**VARSITY MULTI  
SERVICE RE-DEVELOPMENT**

**URBAN DESIGN REVIEW PANEL  
PROJECT PACKAGE**

2021 05 12

# RESPONSE TO PREVIOUS UDRP, CPC, PUBLIC HEARING COMMENTS

West Facade Render

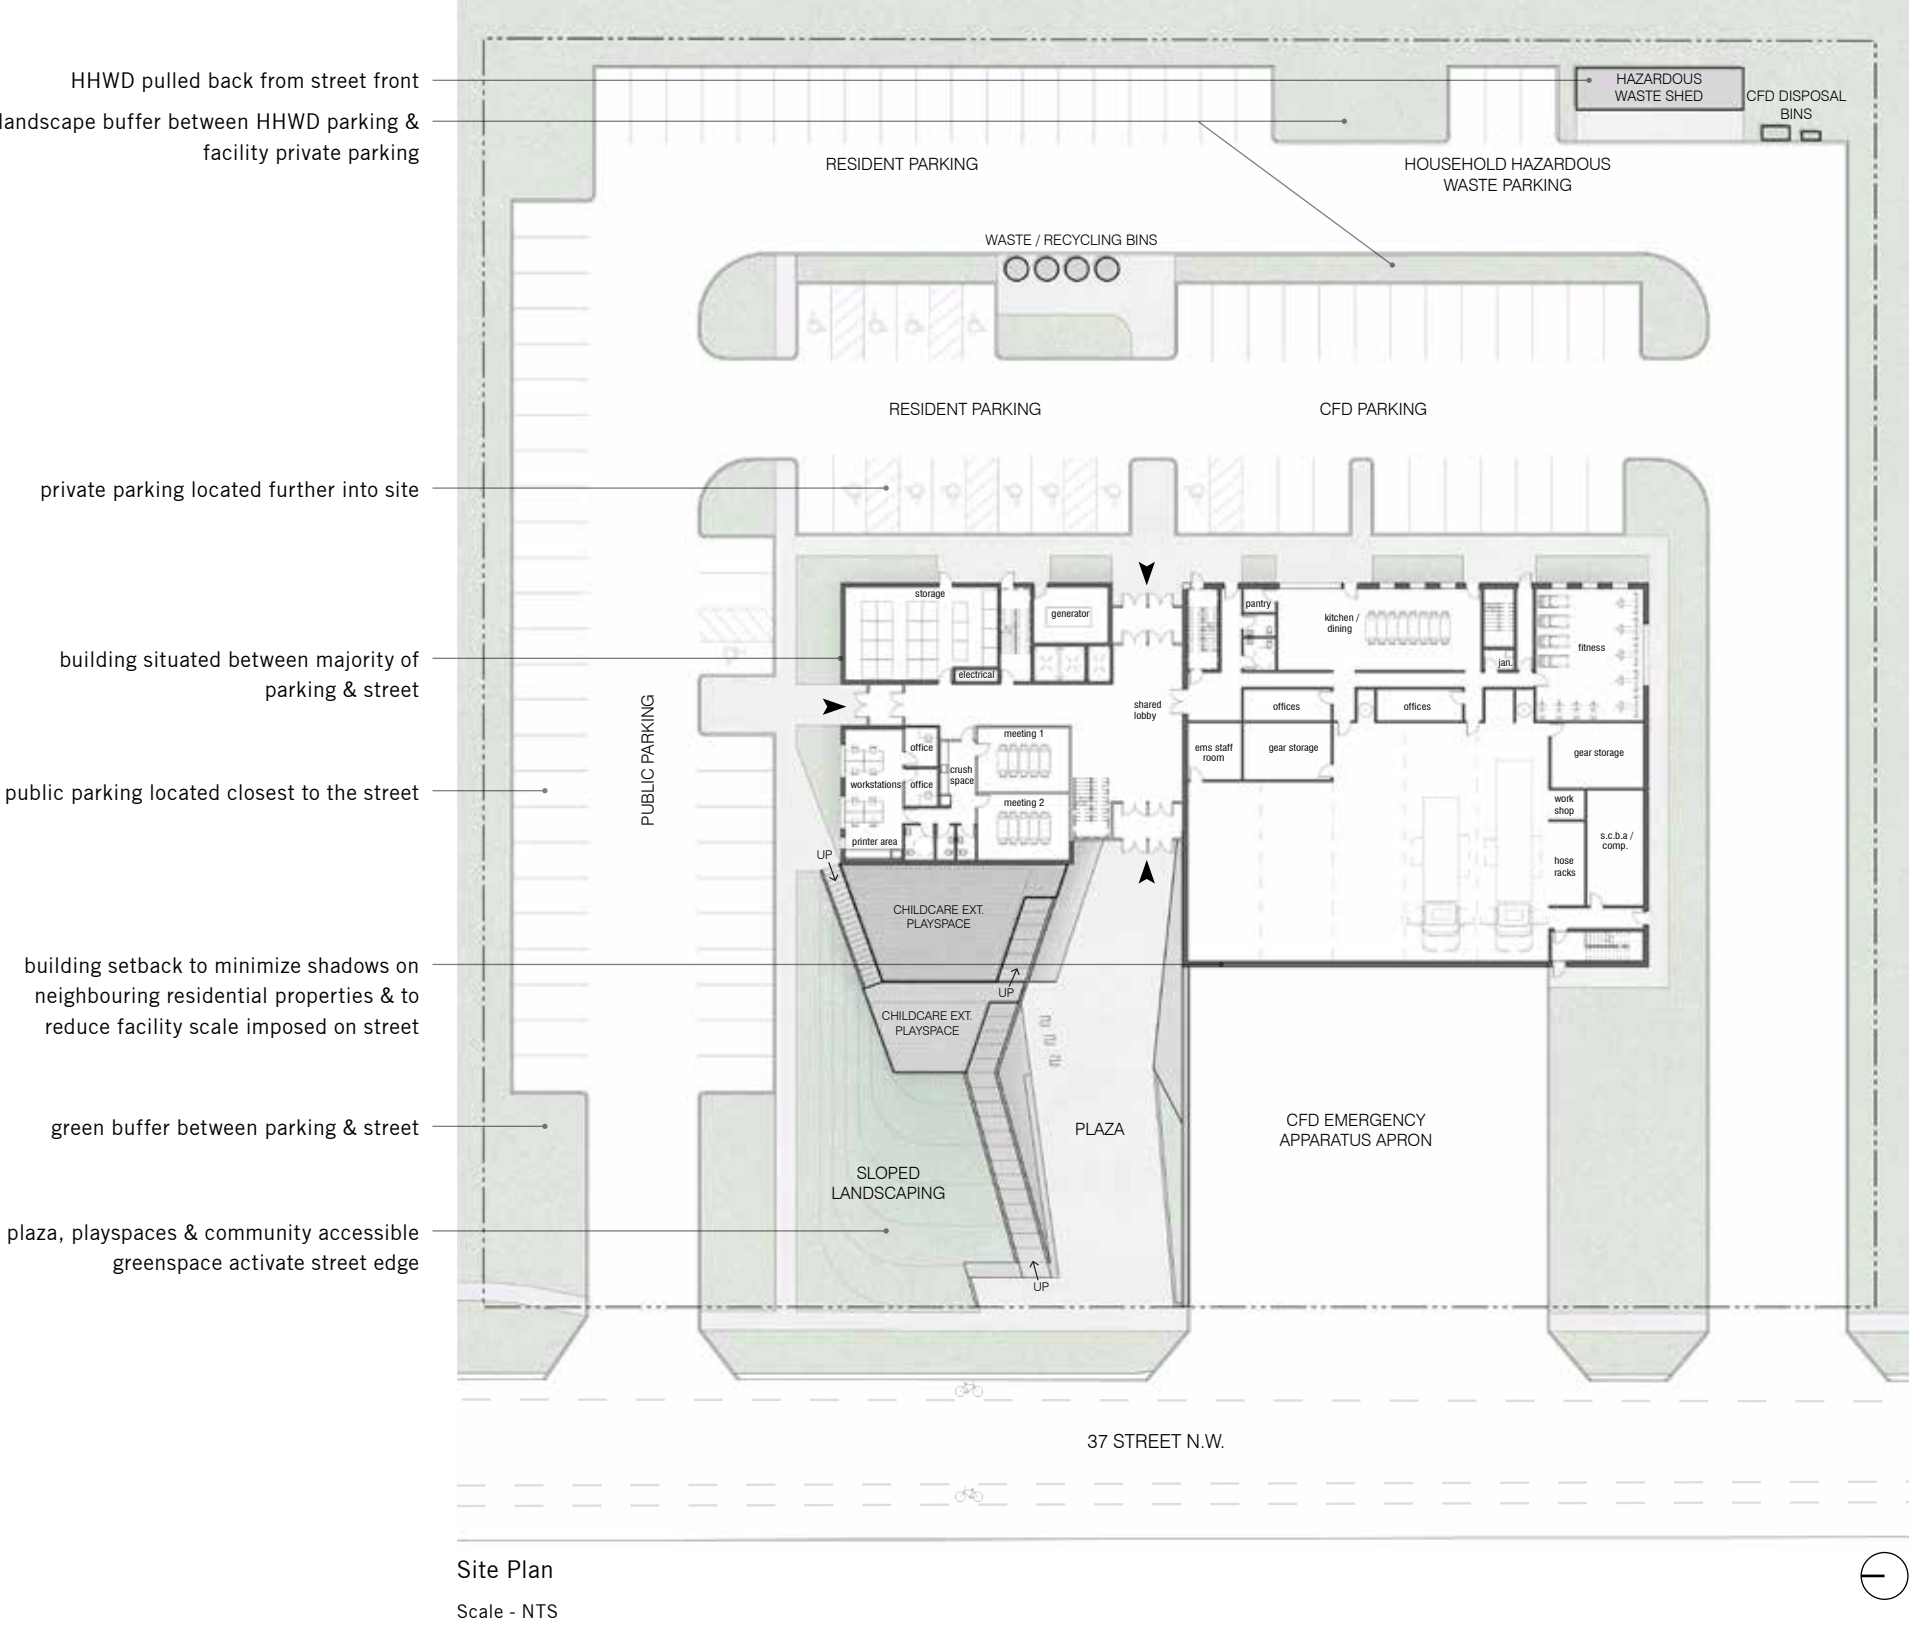
The project's potential for greatest impact and response to the most notable contextual influence is the street edge. This condition is currently defined by multiple driveway interruptions (see Integration below). Excessive surface parking is perceived for the intended building use and the resulting orientation isolates the building with a sea of asphalt. Reduced parking and the elimination of a redundant driveway access is strongly encouraged by the Panel.

While the fire station massing on the lower level may be fixed (due to functional requirements), the remaining building massing appears to be pushed too far from the public realm. Applicant to review shifting the rest of the building towards the street for an improved interface. This gesture could improve several aspects, including a reduction of distance in regard to the front door and the street. This consideration would also decrease the expanse of the 'plaza' area, which is relatively unprogrammed space and likely to be underutilized in the built form.

Integration of 37th Street NW with the public realm is negatively impacted by previously noted vehicular considerations. It is perceived that over 50% of this edge condition is composed of asphalt. The Panel appreciates CFD requirements for the expansive apron, however, challenge the applicant to review the degree interruption of the sidewalk condition. Applicant/owner to review reduced surface parking requirements and the

The landscape plan shows the site surrounded on three sides by a continuous treed edge, which isolates the site from the potential of a shared landscape (as it relates to the adjacent open space areas). Conversely, a continuous treed edge is perceived to be more appropriate along 37th Street for a better interface with the adjacent residential area. Applicant to review the overall landscape strategy for a unified approach to the surrounding edge conditions.

Building design is interesting and incorporates active uses. The overlap of main circulation areas is positive. The Panel is interested in review of the east elevation which was not shown as part of the presentation material.

While barrier free design is proposed in the current submission, the grade difference of the outdoor daycare space separates the natural wayfinding potential and reduces ease of travel. Access to hard play spaces at the front are awkward and appear detached from front terraced landscape area, which is presented as a potential play space for daycare.

As described throughout this response document, pedestrian connectivity is a secondary gesture to the vehicular considerations. The proposed entrance space is unified and continuous which is anticipated to be a successful gesture, however the location of the street facing doors is detached from the street. The plaza is not perceived to be an active space, putting emphasis on reducing the overall length of this space and making the front door more prominent along 37th.

## (A) UDRP RECOMMENDATIONS

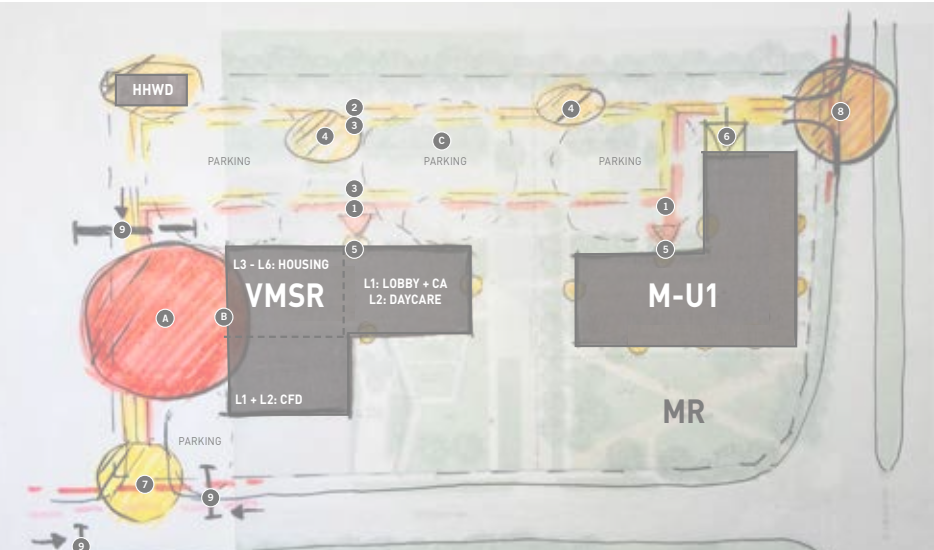
- 1A Reduce parking
- 2A Shift building closer to street edge for improved building-street interface
- 3A Eliminate redundant driveway access
- 4A Acknowledge & connect with existing pedestrian desire lines to adjacent properties

- 1B Resolve access/egress condition details
- 2B Explore entry sequence into the residential project, seeking increased separation between commercial/fire and residential uses
- 3B Integrate the site with surrounding streets, pathways and fire truck operations
- 4B Evaluate access conditions on 37 Street NW and/or the adjacent south site, and provide a comprehensive site access plan
- 5B Evaluate mechanisms for fire truck exit safety; and
- 6B Explore opportunities for improved signal control at the 37 Street and 32 Avenue intersection, for implementation in conjunction with the proposed development.
- 1C The applicant address the matters identified by CPC as well as the comprehensive land use matters including the Concept Plan and arrangement of uses on the site
- 2C The applicant work with Transportation Planning to consider amending the egress away from 37 Street and on to 32 Avenue

### STUDY 1

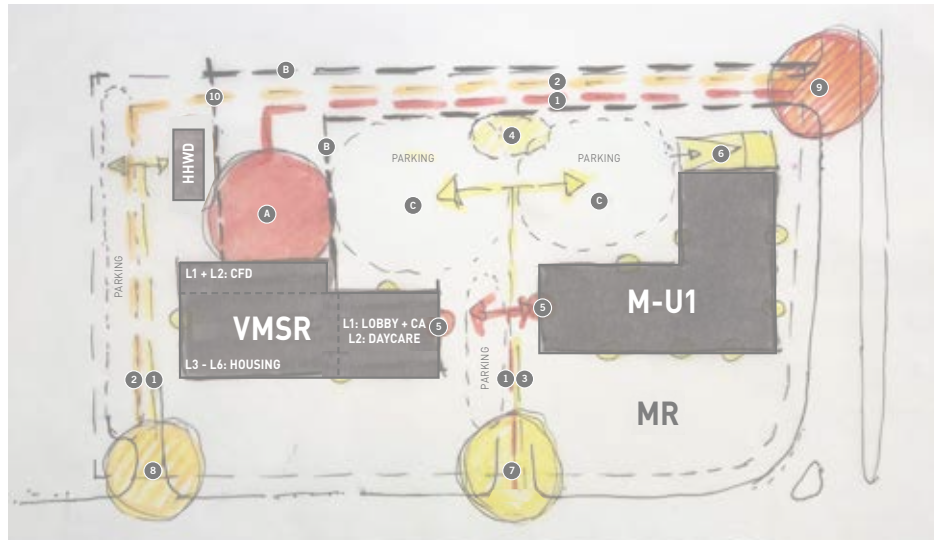
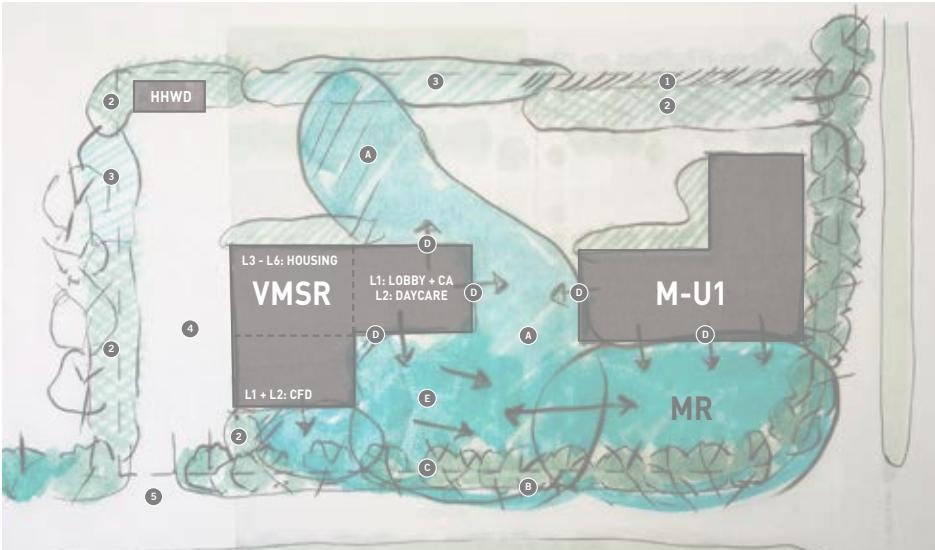
✓ 1A ✗ 2A ✓ 3A ✗ 4A ✓ 1B ✓ 2B ✓ 3B ✗ 4B ✓ 5B ✓ 1C ✗ 2C

- Overlap of CFD apron and public drive aisles within the site
- Not meeting parking requirements for program stakeholders
- CFD emergency access off of 37th Street

### STUDY 2

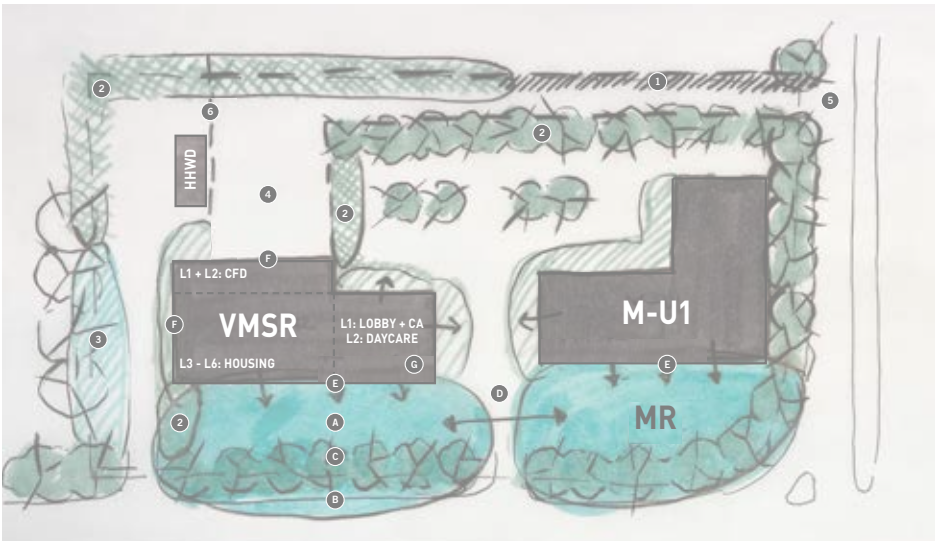
✓ 1A ✗ 2A ✓ 3A ✗ 4A ✓ 1B ✓ 2B ✓ 3B ✓ 4B ✓ 5B ✓ 1C ✓ 2C

- Apron length - does not meet CFD requirements for timed exit
- Apron configuration does not support turnaround as required
- Not meeting parking requirements for program stakeholders
